# Reclamation and Stormwater Inspection

August 17, 2017

Operator: NOBLE ENERGY INC- #100322

Location ID: 433936

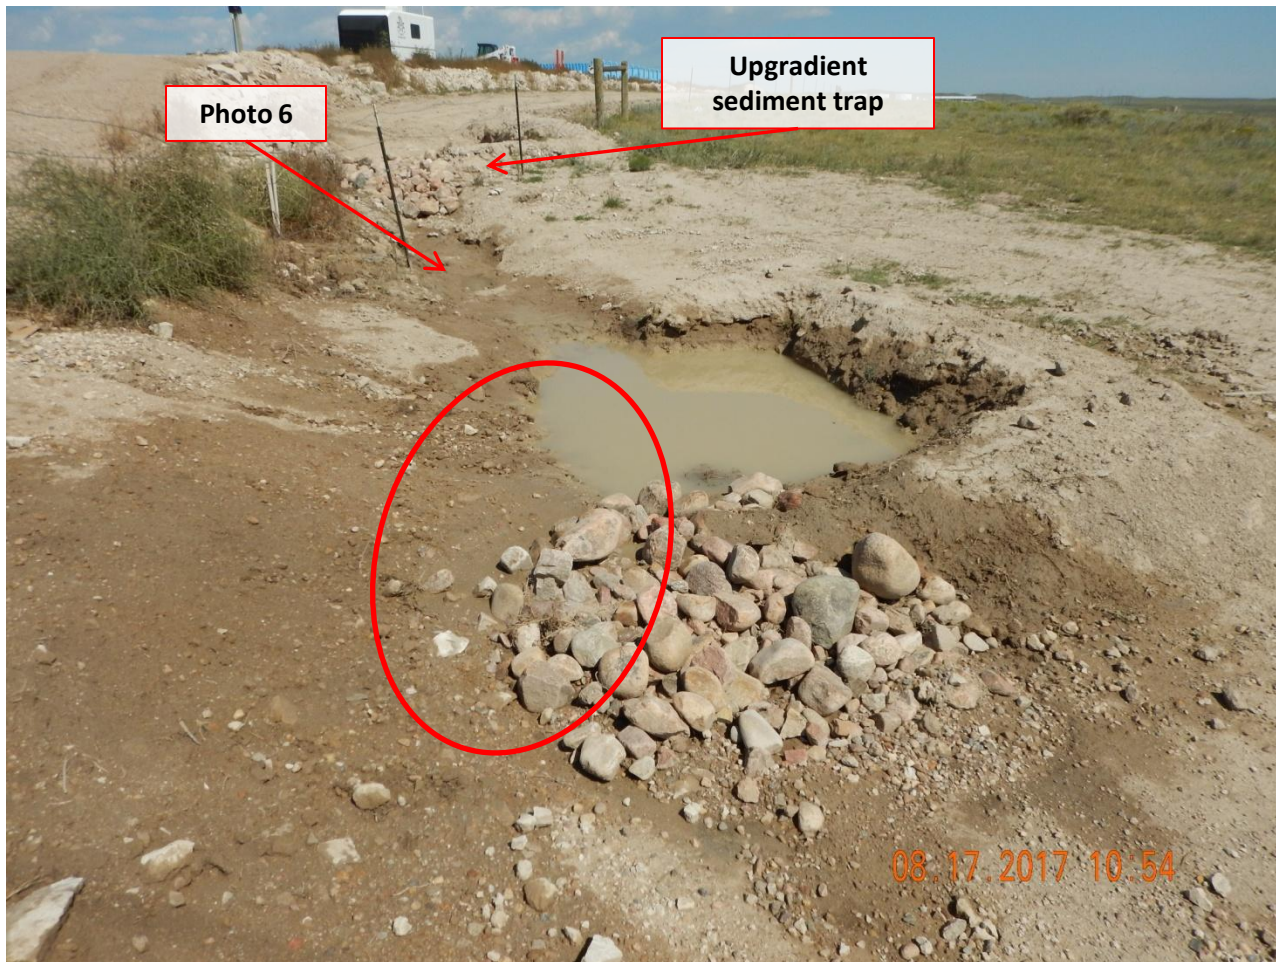
**Photo 5.** Photo taken from the east well pad, east entrance along the east side, facing Northwest. Operator has installed a second sediment trap near the entrance of the location. Embankment material and embankment construction does not appear to be sufficiently compacted, as it appears unconsolidated material could be contributing to sediment loss. Sediment trap outlet area does not appear to be properly constructed to capture outlet flows. Appears sediment laden stormwater is discharging from the western outlet area (red circle). Sediment trap size could be enlarged to help capture sediment laden stormwater runoff.

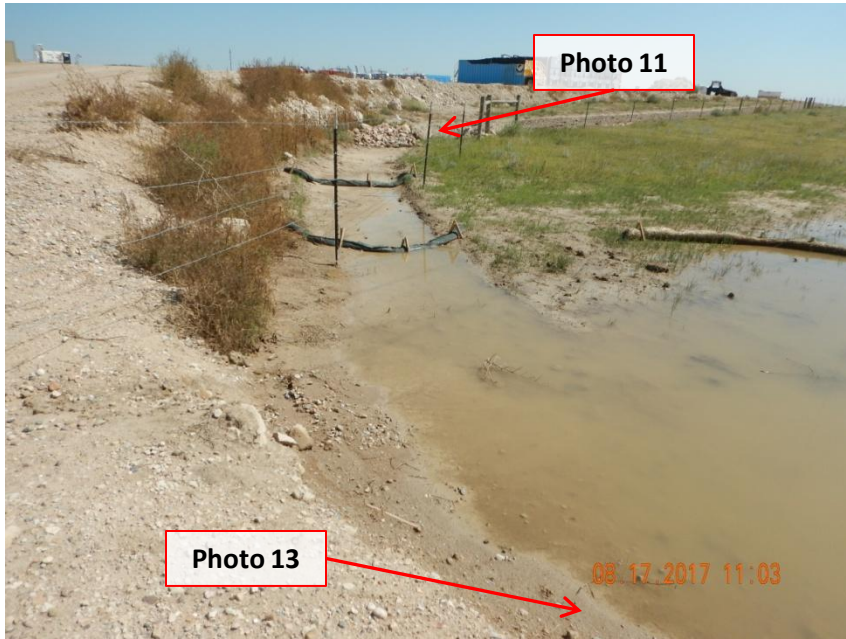
**Photo 12.** Photo taken from the east well pad, west entrance along the east side, facing Northeast. Operator has installed a shallow ditch from the outlet area of the sediment trap to a shallow depression area- refer to Photo 13. Because the sediment trap size is too small sediment would not have enough time to settle out before discharging out of the outlet. Wattles are intended to pool sheet flow (not filter sediment) and it appears the volume of stormwater sheet flow, likely sediment laden flow, is overtopping the wattles.

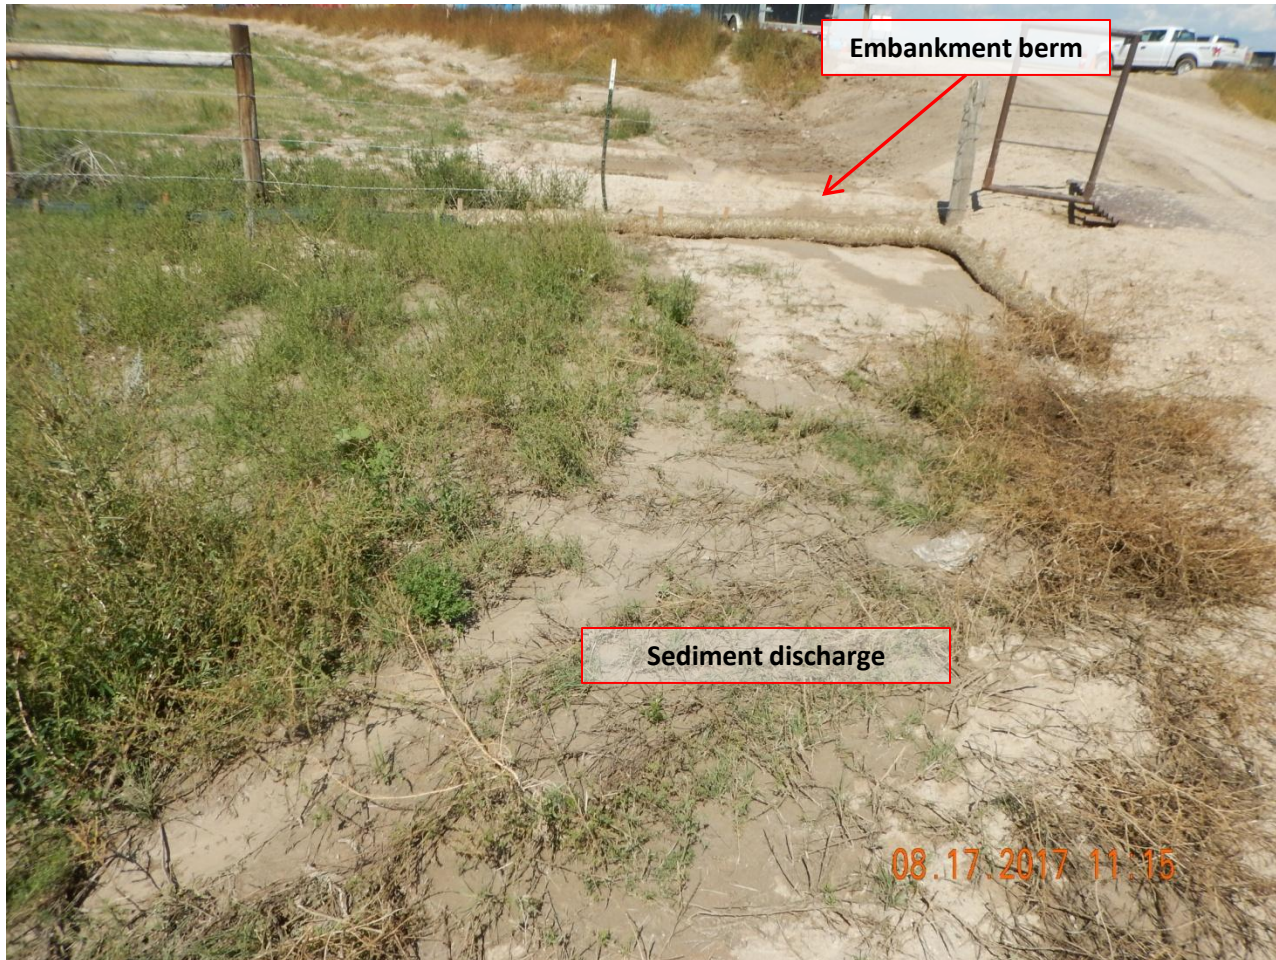
**Photo 20.** Photo taken east of the previously shown sediment trap in Photo 17. Photo illustrates sediment loss from stormwater overflowing from the sediment trap. Does not appear the wattles installed along the outer perimeter of the sediment trap are preventing sediment discharge. Wattles are intended to pool sheet flow (not filter sediment).
